Client	Gabrielli Constructions Pty Ltd		 INSPECTION AND TEST PLAN
Contract No:	43123		
Project Name:	Wellington Street Depot		
Task:	Inground Stormwater – Stage 1 Carpark	ITP: In Ground Stormwater

Construction Inspection Report

Project: Wellington St Depot, Stage 2	Job No: STP21-0817
Address: Wellington St, Mundingburra	Inspection No: 03

Proof roll subgrade inspection 10/06/23 2:00pm

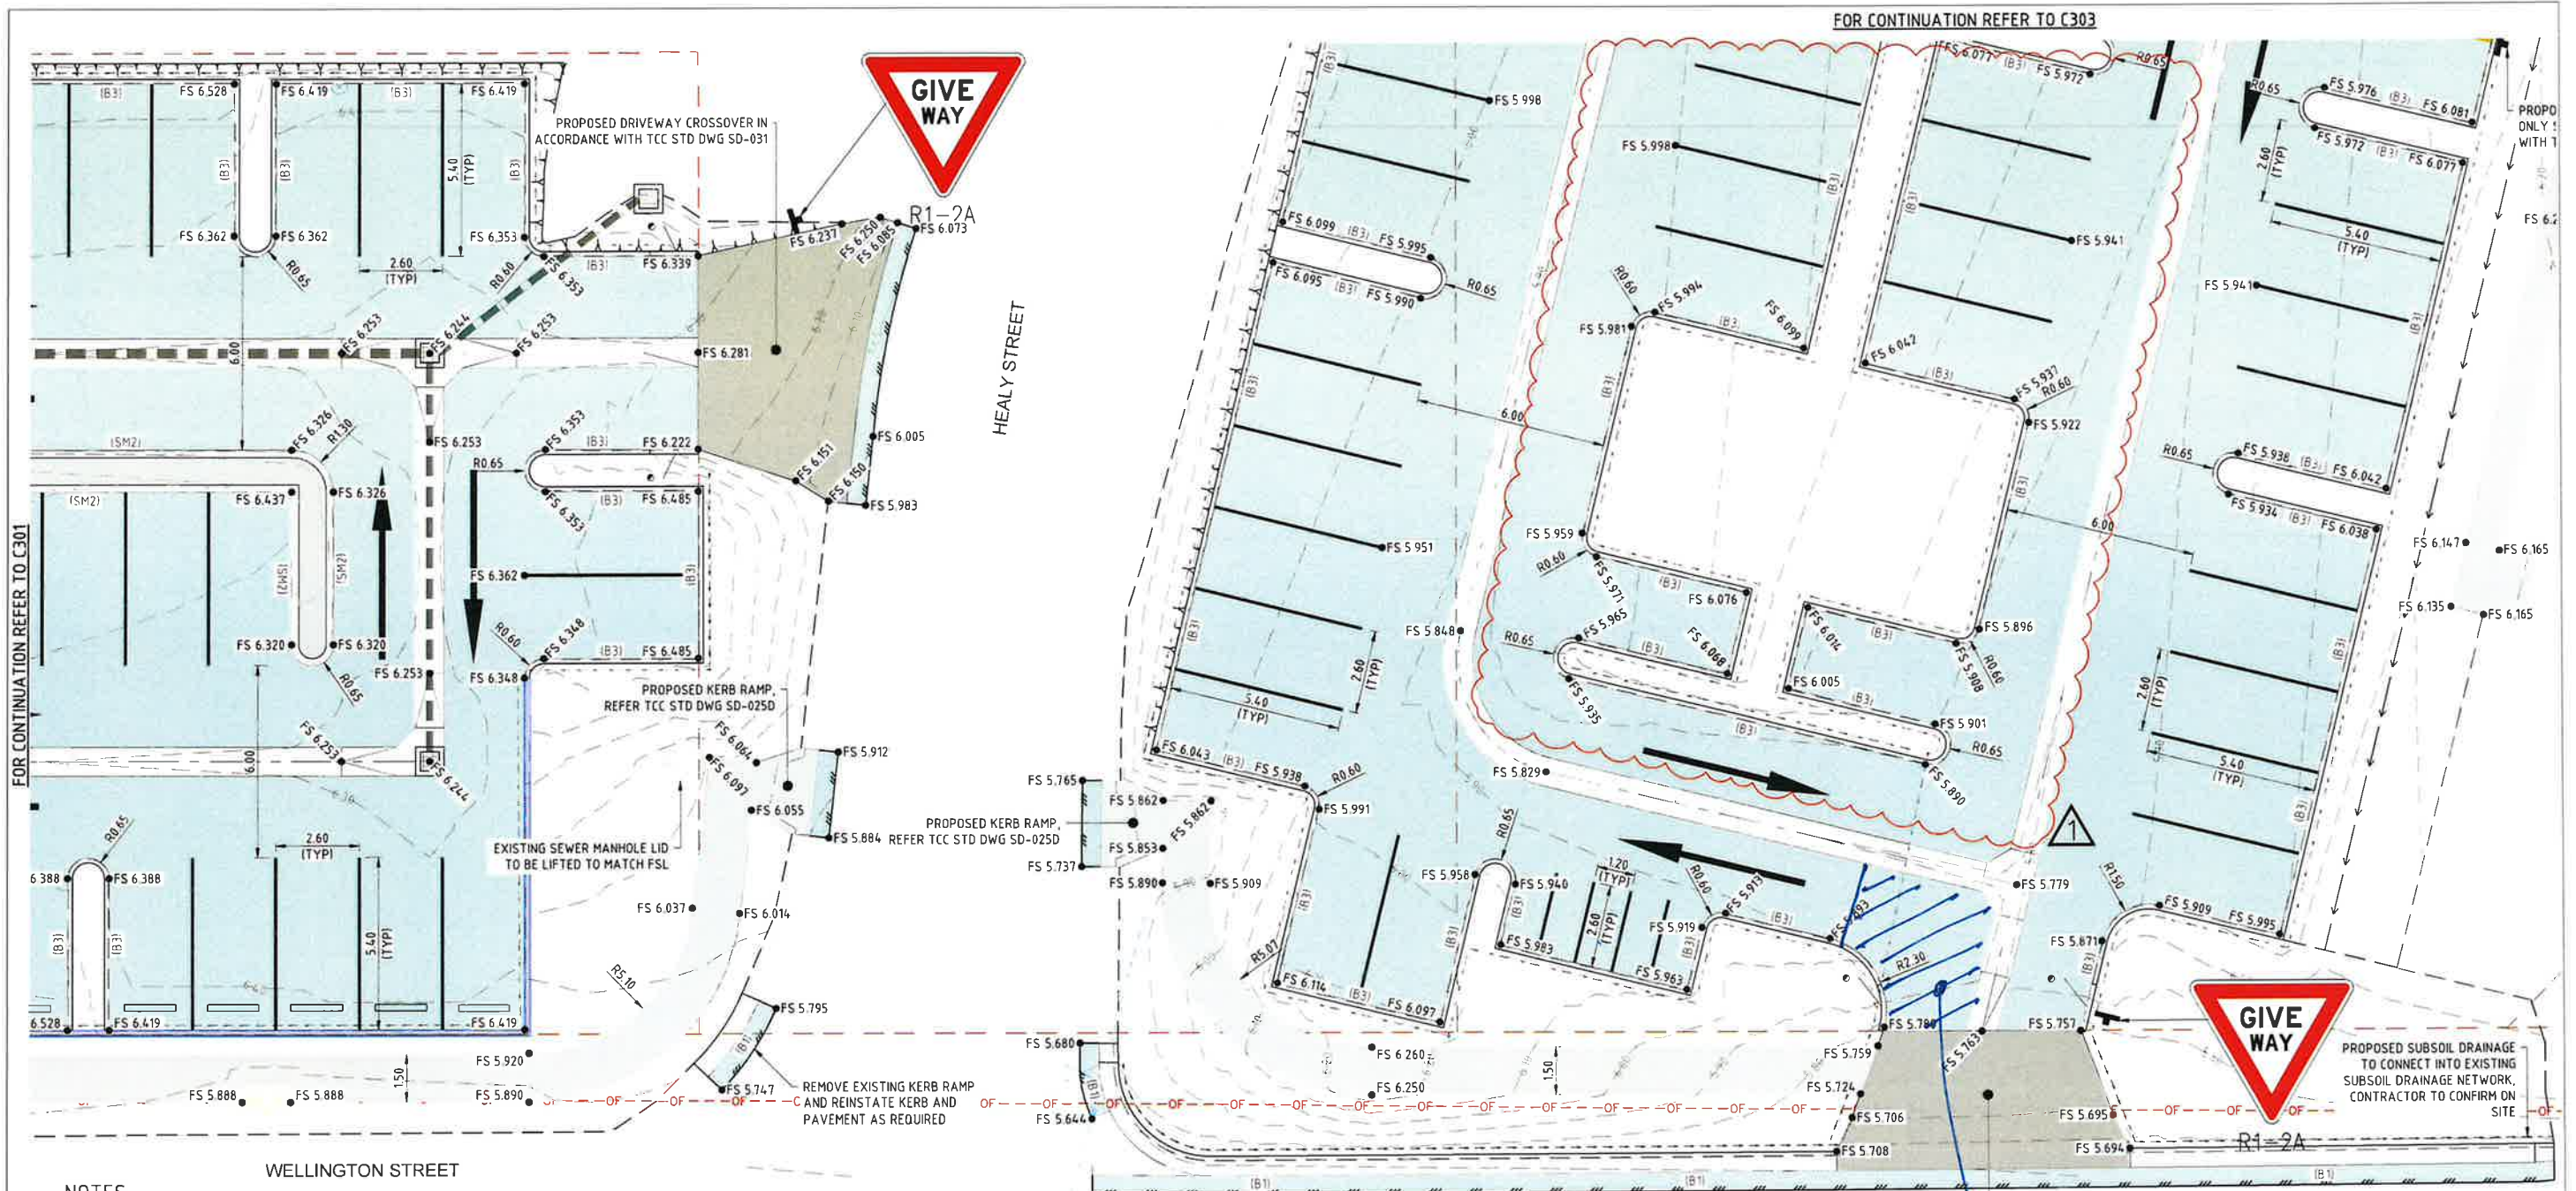
Practically the entire pavement area showed excessive movement and sponginess, especially the darker coloured areas.

A 300mm deep trench was also excavated to investigate the depth of the unsuitable material. This indicated that the material continued to some depth too deep to chase.

It is recommended that the subgrade be removed to a depth of 200mm below the design subgrade level and replaced with a 200mm layer of Type 2.5 material.

A further proof roll should then be undertake to determine whether Tensar will be required.

If there is movement detected then it is recommended that a layer of TX160 or equivalent be installed at subgrade level.

The design pavement may then be installed over this layer or directly on the subgrade of there is no movement.

Inspected Amenities frame.

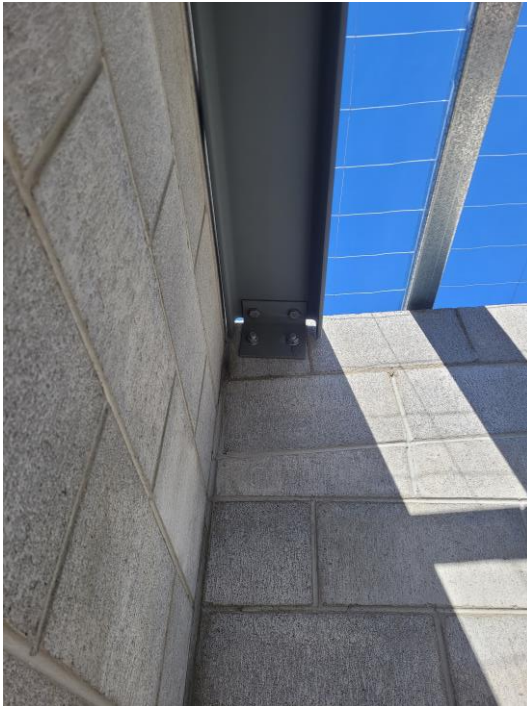
Structural framing complete.

Member sizes and connections are consistent with construction issue drawings.

Inspected irrigation workshop roof frame.

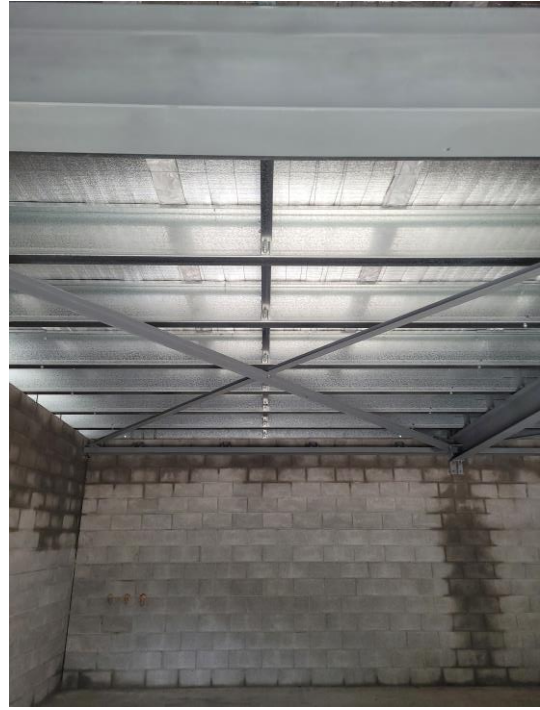
Structural framing complete.

Member sizes and connections are consistent with construction issue drawings.

Time of Inspection: Start: 2:00pm End: 3:00pm	Date: 20.09.2023
Type of Inspection: Subgrade Layer	Inspection Conducted by: Ken Miller

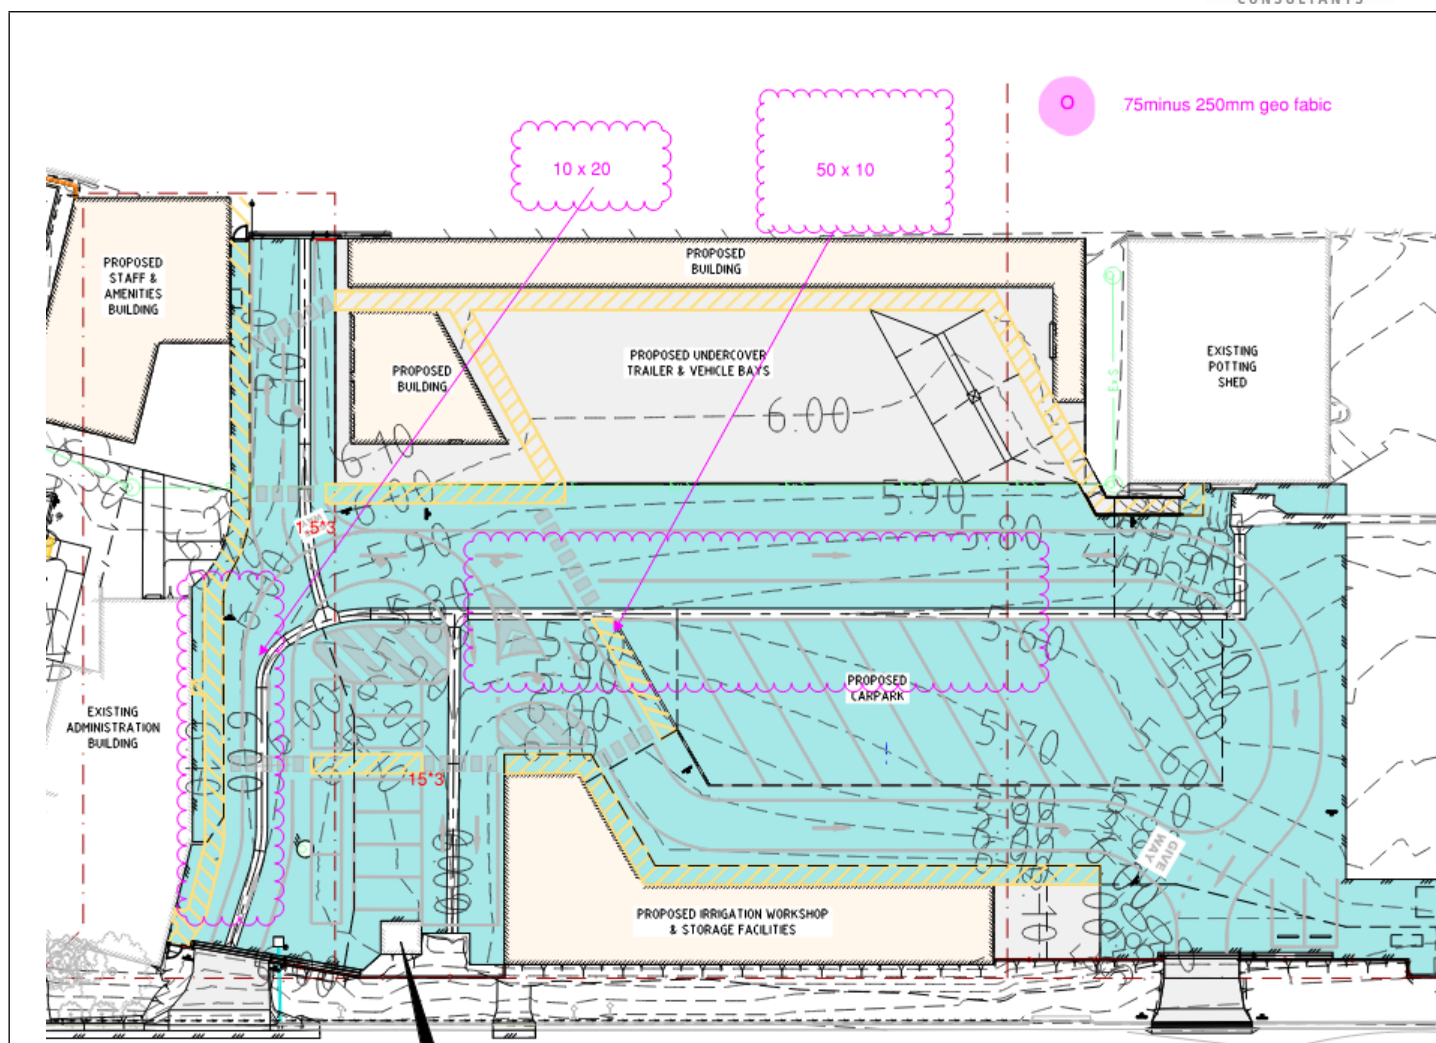
Comments
Work Elements Inspected: - Subgrade layer Stage 2 hardstand proof roll. Machinery Employed: - A 3-axle water truck was organised and loaded on the day of the test. Conformance with Design and Documentation: - The extent of subgrade is in accordance with the STP plans and documentation and recommendations. Quality of Workmanship: - The presentation of the worked subgrade was clean, free of debris, and of natural site won material. Defects: - Deflections noted as per the site markup below. Conclusion: Subgrade layer FAILED the proof roll inspection and will not be approved without further remediation. Recommended remediation measure for the areas detailed below are as follows: - Remove existing subgrade to a depth of 250mm. - Trim and compact exposed surface. - Install layer of A44 Geofabric - Install 250mm layer of 75minus material. - Compact and trim. - Further proof roll required over remediated areas.

Additional inspections were also undertaken on this occasion for pre-pour of an electrical pit walls and the lintels and grates of the stormwater pits in Stage 1.

Inspection of these items was satisfactory, and works may proceed.

Time of Inspection: Start: ____ 9:00am ____ End: ____ 10:00am ____	Date: 16.10.2023
Type of Inspection: Subgrade Layer	Inspection Conducted by: Ken Miller

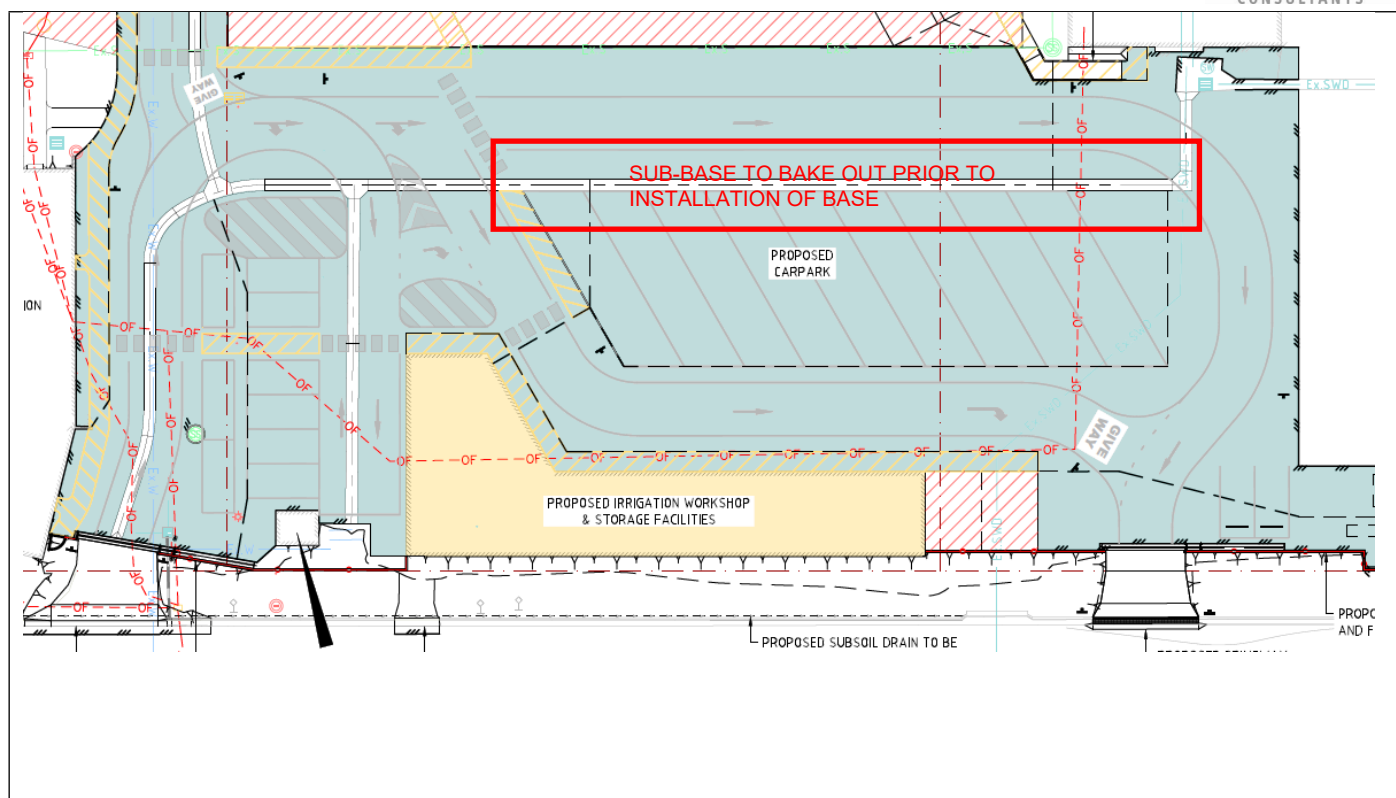
Comments
Work Elements Inspected: - Sub-base layer Stage 2 hardstand proof roll following subgrade approval. Machinery Employed: - A 3-axle water truck was organised and loaded on the day of the test. Conformance with Design and Documentation: - The extent of sub-base is in accordance with the STP plans and documentation and recommendations. Quality of Workmanship: - The presentation of the graded sub-base was wet in the invert section and showed ponding in several places. Defects: - Deflections were observed in the area shown, to 3m each side of the invert. Conclusion: Subgrade layer has partially PASSED the proof roll inspection and will be approved after allowing the centre section to bake out. Next inspection to be proof roll of the base surface prior to sealing.
